TOWN OF HUDSON

PUBLIC MEETING TOWN OF HUDSON, NH AUGUST 8, 2018

Pelham Yards Amended Site Plan STAFF REPORT

Reeds Ferry Small Buildings Site Plan STAFF REPORT

17851.04 PR JH FB — CK RED CADFILE 17851.04 SITE SHEET 6 OF 17

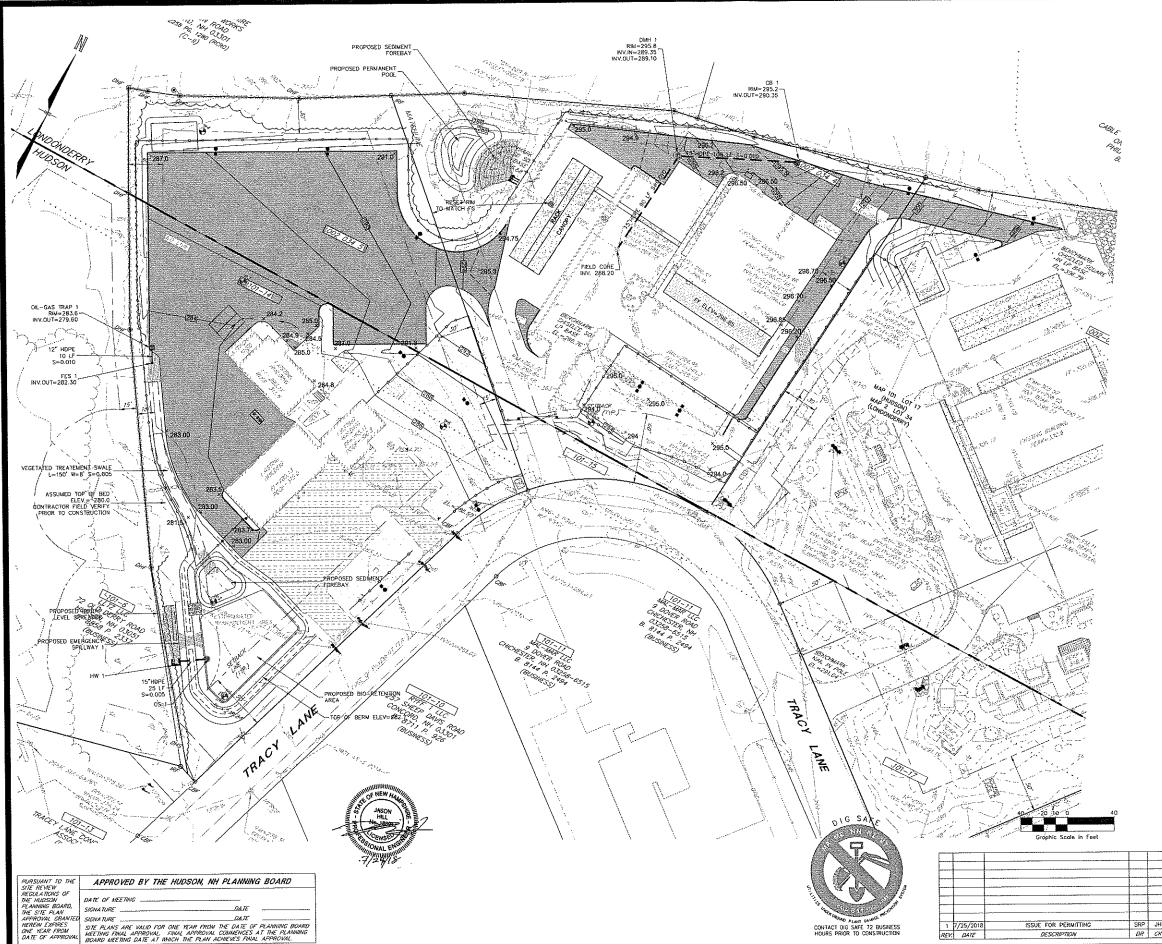
- 7. Prior to Planning Board endorsement of the plan, it shall be subject to final review by the Town Engineer and CLD.
- 8. Construction activities involving the subject lot shall be limited to the hours between 7:00 A.M. and 7:00 P.M. No exterior construction activities shall be allowed on Sundays. Note 19 on Sheet 6 shall be revised to match this stipulation.

- 9. Hours of refuse removal shall be exclusive to the hours between 7:00 A.M. and 7:00 P.M. Monday through Saturday only. A new Note shall be added to Sheet 6 to match this stipulation.

OIL-GAS TRAP 1

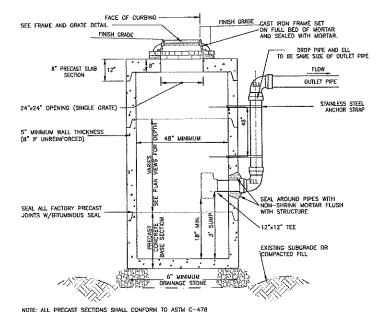
- c. HR 290-4.C. The Outlet Structure 1 Detail on Sheet 11 states "Oil-Gas Trap Tee (See Detail)". The applicant should provide additional information on the detail being referred to.

17851.04 DR JH FB -SHEET 12 OF 17

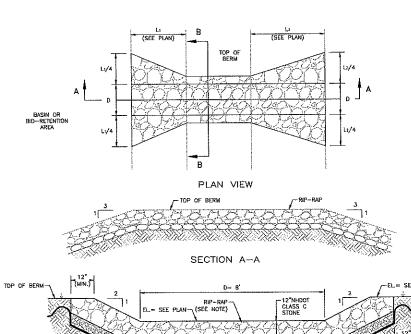
- b. HR 290-4.C. We note the rip rap calculations within section 6 of the Stormwater Drainage Report do not match the dimensions listed within the detail upon Sheet 12.
